May 5, 2021

Product Change Notice - Protective rubber overmold added to In-Wall Slide-out motors

500:1

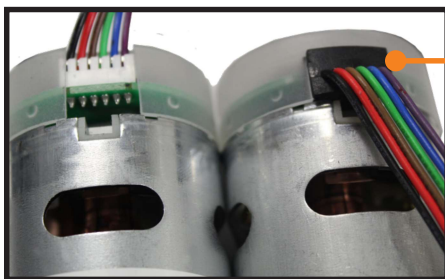
Please be advised, as part of continued improvement to overall motor durability, Lippert intends to add a protective rubber overmold to the 500:1 and 300:1 In-Wall Slide-out motors where the wire exits the motor.

Protective
overmold

Current

New

300:1

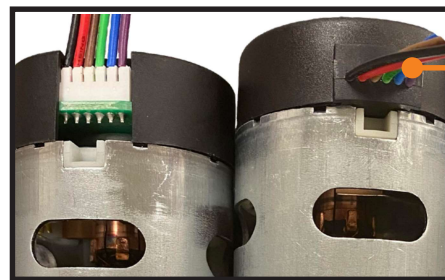
Protective
overmold

Current

New

Black wrap on
sample only
